PROJECT: San Francisco Oakland Bay SAS Bridge Superstructure
Caltrans Contract No. 04-0120F4
ABF Job No. 660110

SUBJECT: Request for Change Order (RFCO) No. 19 – RFI 876R0 and 944R0
Design Deficiencies on PWS Cable Geometry near Pier E2 and from PP 111 to PP 118

RFI No.: ABF-RFI-000876R00 Submitted By: Smith, Kevin Pages: 5
 RFI Date: 17-August-2007 Contact Name: Smith, Kevin Phone No. (412) 631-1000
 Pages Attached: 4

Subject: PWS Cable Geometry Near Pier E2	
References:	
Sub/Sup: ABF	Sub RFI #:
Response Required by: 24-August-2007	Response affects critical path activity? Maybe

CABLE GEOMETRY NEAR PIER E2
 WESTBOUND BRIDGE
 PANEL POINTS 112 - 116

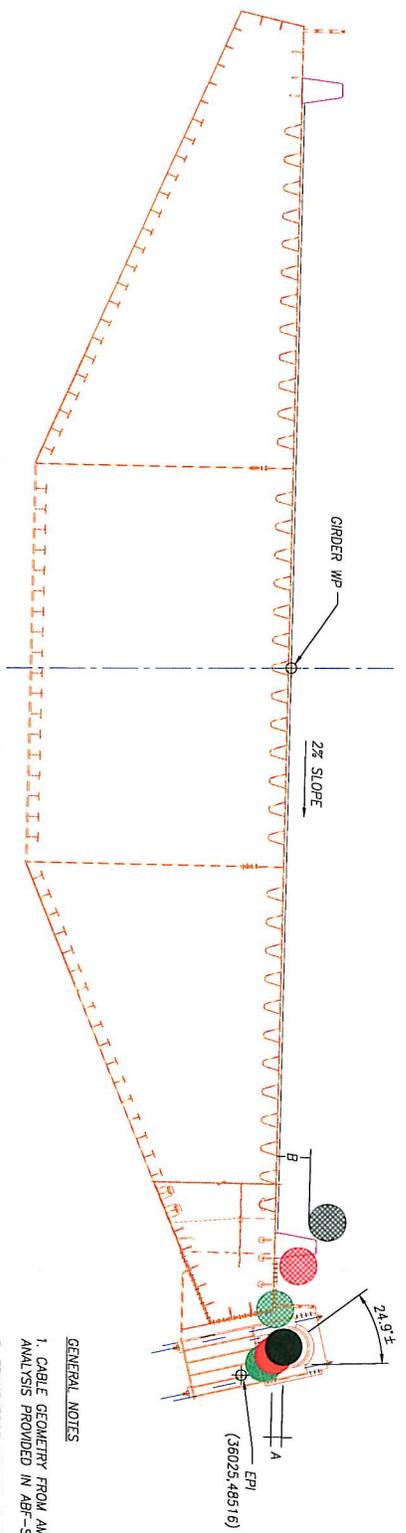
1. The freehanging main cable interferes with the EB and WB box girders at PP116.
2. The loaded main cable interferes with the EB suspender bracket at PP110.

3. The main cables will interfere with the suspender brackets on the EB and WB girders during load transfer.
4. Cable compaction and cable wrapping near Pier E2 will not be possible due to the limited clearances between the cable and the box girder.

5. At PP112, PP114 and PP116 the suspender bracket geometry required to match the location of the loaded main cable will be significantly different than the dimensions (13.5°, 850mm and "A" dimension) shown on Contract Drawing number 744. As discussed in the most recent OBG Team Meeting held at the Working Drawing Campus, the detailing of these suspender brackets has been placed on hold until it is clarified how the suspender brackets are to be detailed to meet the design requirements. Further meetings at the Working Drawing Campus would be useful to resolve this issue.

1. The conflict of the free-hanging cable with the box girder in the vicinity of the East Saddle was identified in notes 3 and 4 of sheet 978/1204 and note 6 of sheet 967/1204. The Contractor was directed to take necessary measures to avoid interference between the cable and the deck during construction. The Contractor's erection solution to this interference will impact other items noted in this RFI.

2. The suspender forces chosen for the final cable profile control the cable clearances over the suspender brackets. Note that the north and south cables are at differing elevations with respect to the girder, and that the moment diagram reported in Submittal #232 (currently under review) is slightly out of limits in the vicinity of PP 110. Therefore, a relaxation of suspender forces is available to the Contractor, which should eliminate the noted cable – EB suspender bracket conflict.

5. The cable location should match the bracket location “by definition.” The cable geometry should be determined by the requirement that the cable passes through the brackets, as explained in the response to RFI 776. The brackets positions may be adjusted along the line defined by the 13.5° angle, or another approved angle.

Made By: <u>L. Gatsos</u> Date: <u>9/24/2007</u> Checked By: <u>K. Smith</u> Date: <u>9/24/2007</u> In Charge Of: <u>R. CROCKETT</u> AB Job No. 660110	OBG CORNER ASSEMBLY CUTOUT PP112-PP117	Scale: N.T.S. Sheet No. 1 of 3
--	---	---

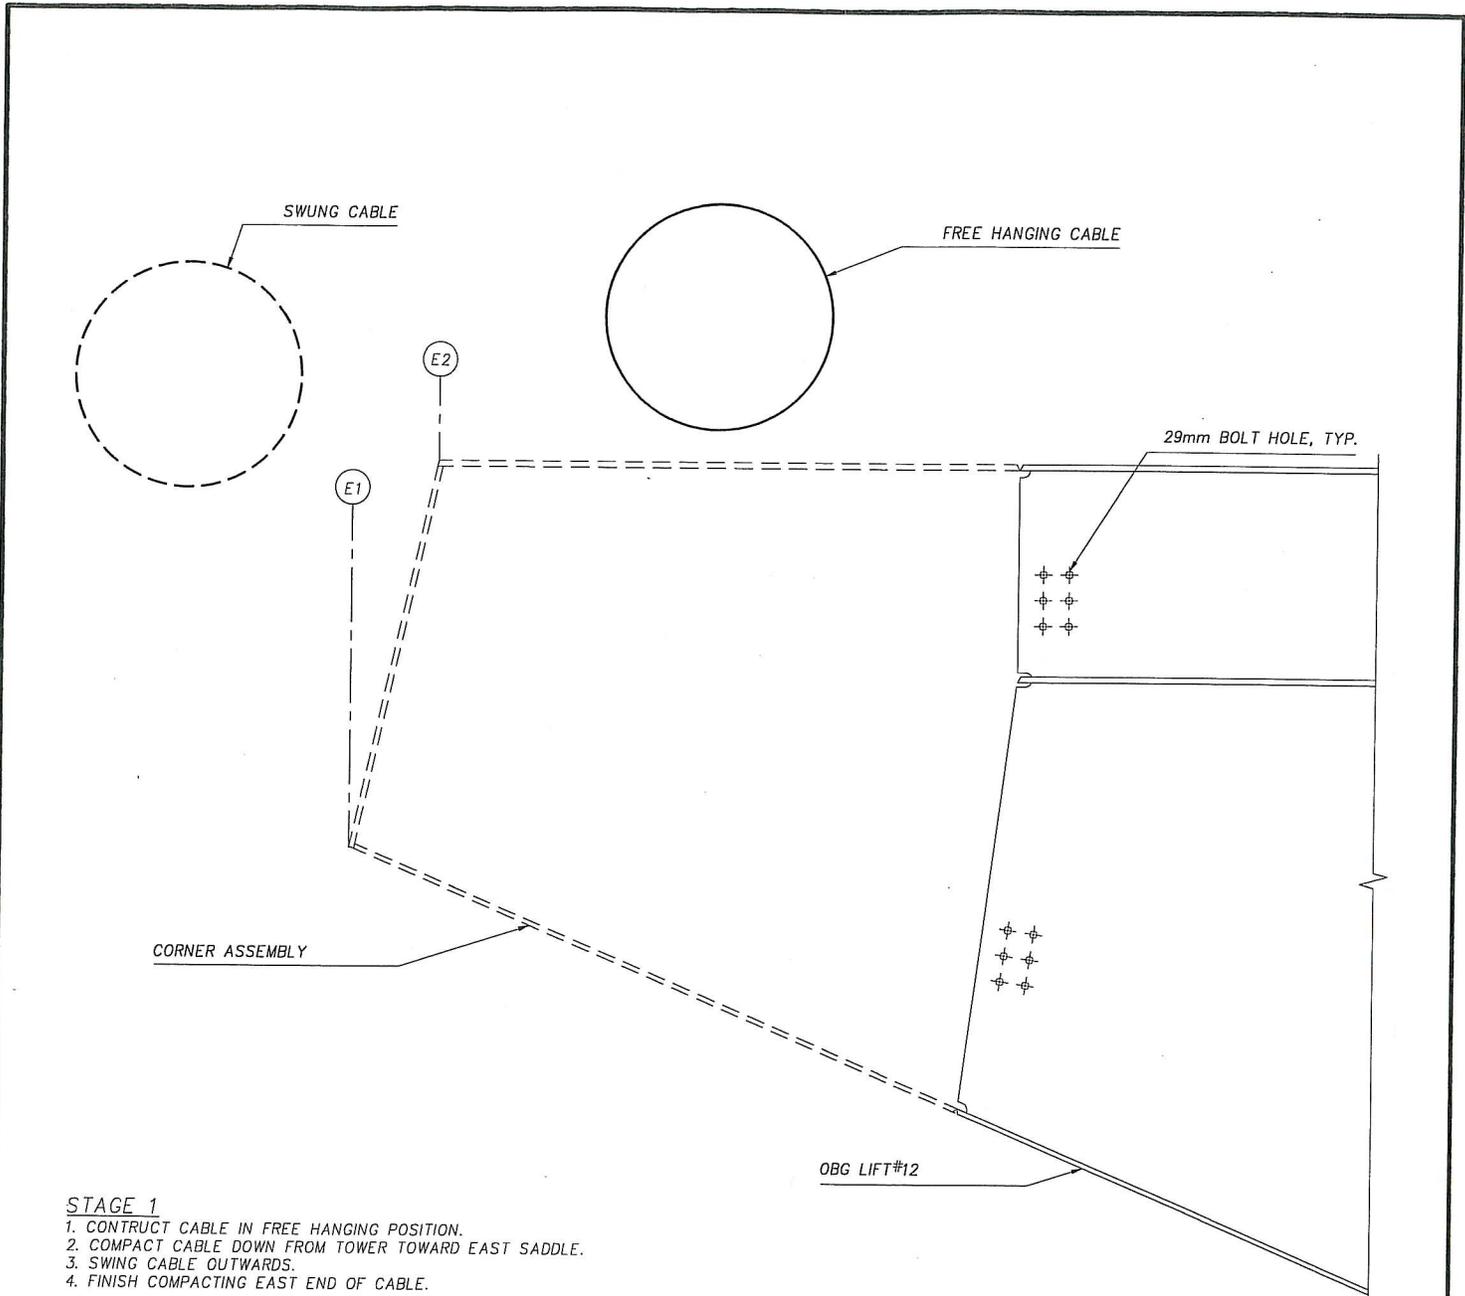
To accommodate the free hanging cable interference with the OBG, identified in ABF-RFI-000876R00, ABF proposes to field install the corner assembly from PP111+700 to PP118-1700 (field splice #12). For additional information please reference the attached sketches. In regards to this, we request the following:

1. ABF proposes to temporarily bolt the Corner Assembly to floorbeams at PP112-117, as shown on the attached sketches.
2. ABF proposes to field weld the Corner Assembly from PP111+700 to PP118-1700 to east bound and west bound box girders.

The Department takes no exception to the Contractor's proposal to field install the corner assemblies from PP 111+700 to PP118+1700. With regards to the specific proposals:

1. No exception taken.
2. No exception taken.

Suitable measures shall be taken to prevent moisture/water from being introduced into the box girder during shipment.

1. Calculations to substantiate the details
2. Revisions to axial camber for the corner assembly
3. The corner assembly shall be fit to the OBG segment and precisely aligned.
